Genesis Fashions Ltd Columbia Apparels Ltd

228/1, Tin Sarak, Luxmipura, Joydevpur, Gazipur- 1700
(23.99435N, 90.40443E)

2nd March 2014

Risk of vehicle impact to column

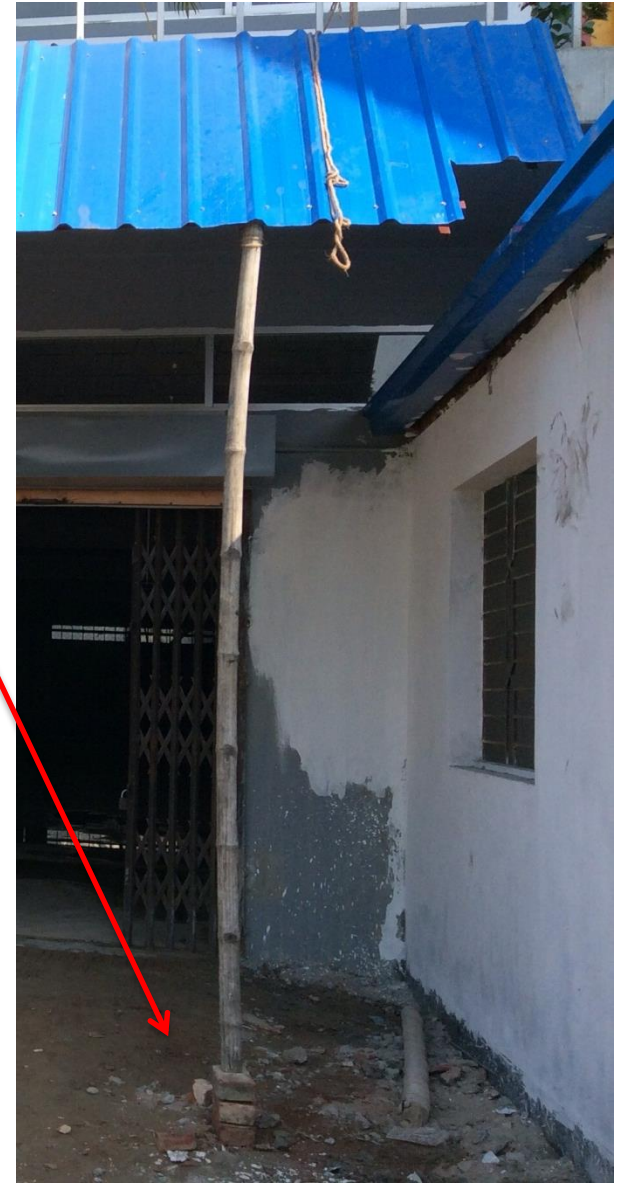
Column exposed to vehicle impact

Column supporting several stories exposed to vehicle impact in loading area
No physical barrier to collision

Item No.	Observation	Recommended Action Plan	Recommended Timeline
8	Check required on roof structure from localized high loading from water tanks.	Building Engineer to check that slab has sufficient capacity to support fully filled water tanks and relocate if necessary – note also Item 1 actions	6-weeks
9	Materials stacked in dense piles / storage racks	Ensure that stacks of materials are separated by a 0.5m gap all around.	6-weeks
10	Materials stacked in dense piles / storage racks	Building Engineer to check capacity of existing structure to carry storage loads	6-weeks
11	Materials stacked in dense piles / storage racks	Building Engineer to create controlled loading plans (see also Item 1) for all floors designating where storage can be placed	6-weeks
12	Materials stacked in dense piles / storage racks	Continue to implement loading plan	6-months
13	Column at loading bay of main building vulnerable to vehicle impact	Provide physical barrier or other protection to column to prevent vehicle impact.	6-weeks

Non-engineered structures - canopies

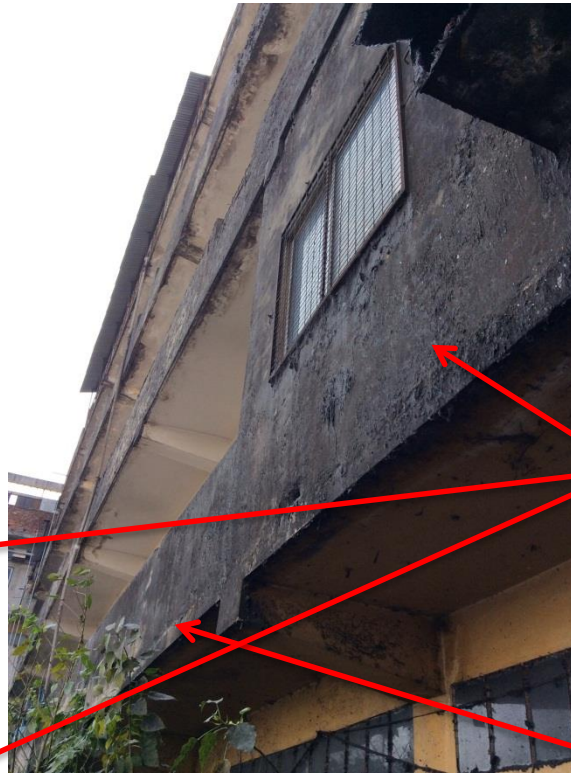
Non-engineered structures

Canopies and supports seem unstable
Danger of localised collapse

Item No.	Observation	Recommended Action Plan	Recommended Timeline
15	Canopy and supports at main building appear non-engineered	Building Engineer to check the supports and propose revised supports to ensure stability under dead, live and accidental loading.	6-weeks
16	Canopy and supports at main building appear non-engineered	Support details to be upgraded as per building engineer's design.	6-weeks
17	Water causing damage and corrosion on façade due to unmanaged drainage	Manage drainage from above levels and water tanks to downpipes to avoid structural corrosion due to continuous moisture.	6-months
18	Water causing damage and corrosion on façade due to unmanaged drainage	Exposed reinforcement not to be used for any structural applications	6-months
19	Rear wall of security hut/boundary wall appears non-engineered and leaning.	Factory engineer to check stability of wall and propose remedial actions.	6-weeks

Non-engineered structures – extension onto balcony

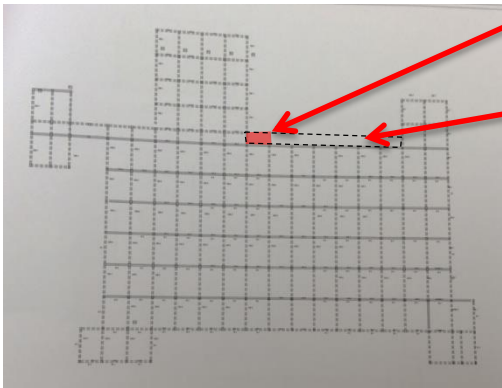
Factory floor built out onto balcony with additional masonry walls built to full storey height

Normal balcony (not shown on drawings)

14	Building extension onto cantilever balcony requires engineering check	Building Engineer to check the cantilever beams and slabs to ensure adequate load carrying capacity. Note also Item 1 requirement for DEA	6-weeks

Non-engineered structures – edge protection

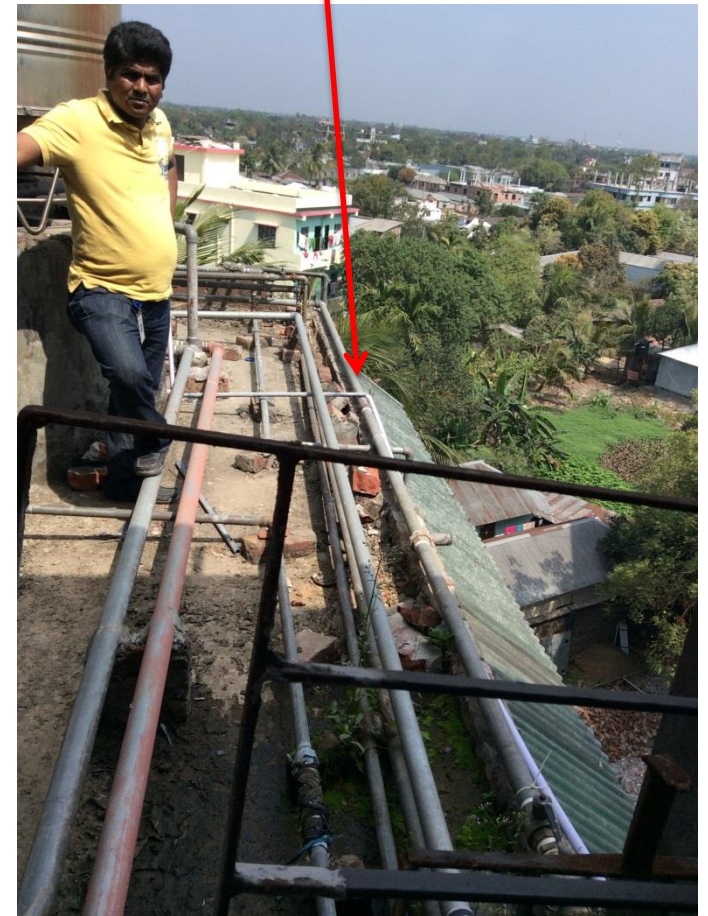
Non engineered railing to balcony at high level

Lack of edge protection near water tanks

Water causing damage and corrosion

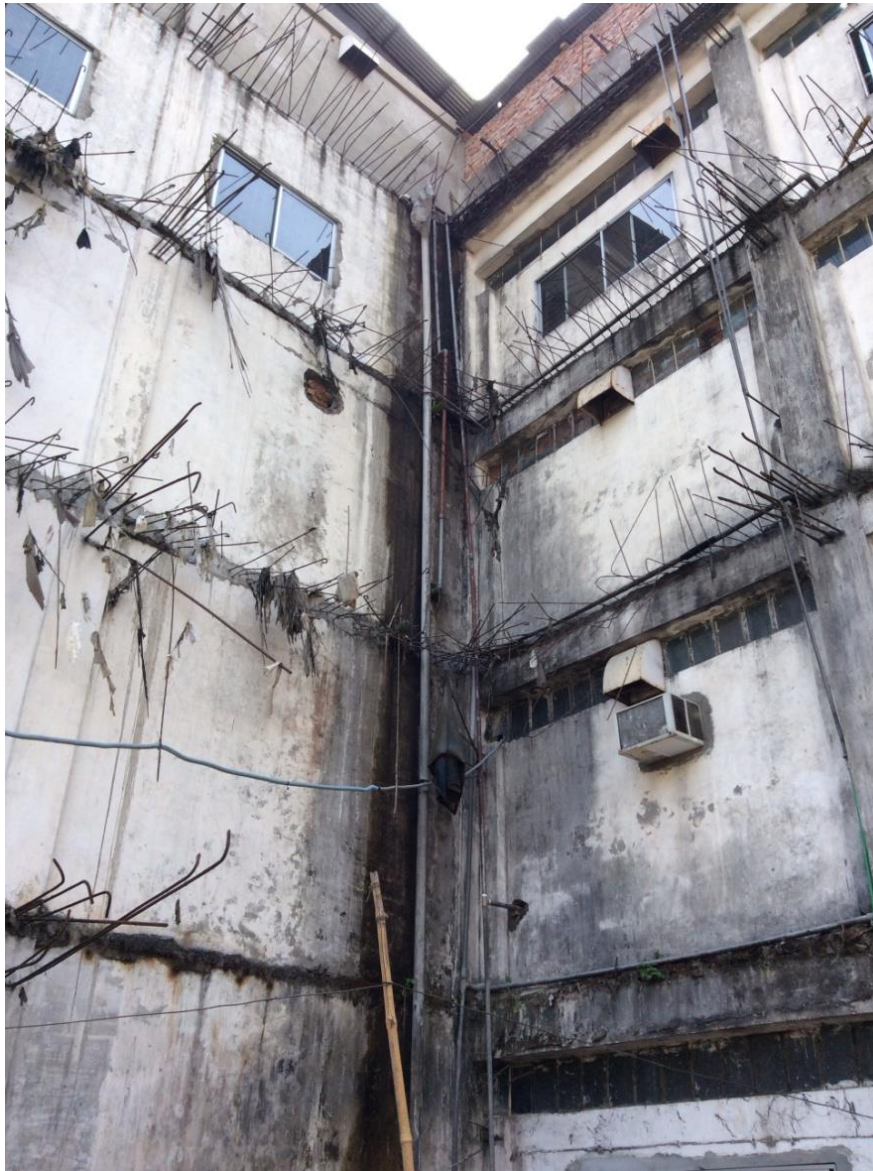
Water causing damage and corrosion

Reinforcement unsuitable for use in future horizontal extensions due to corrosion

Movement joint cosmetic cracking

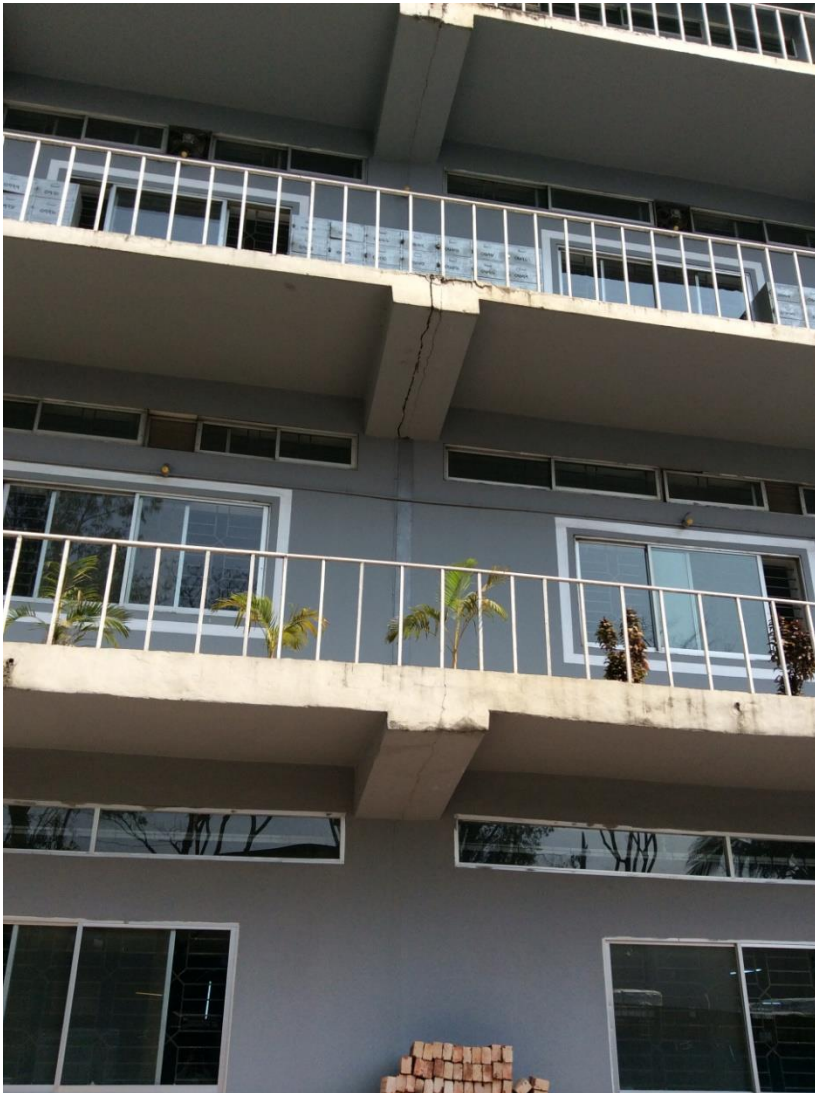
Movement joint cracking (non-structural)

Risk of material falling out of movement joint
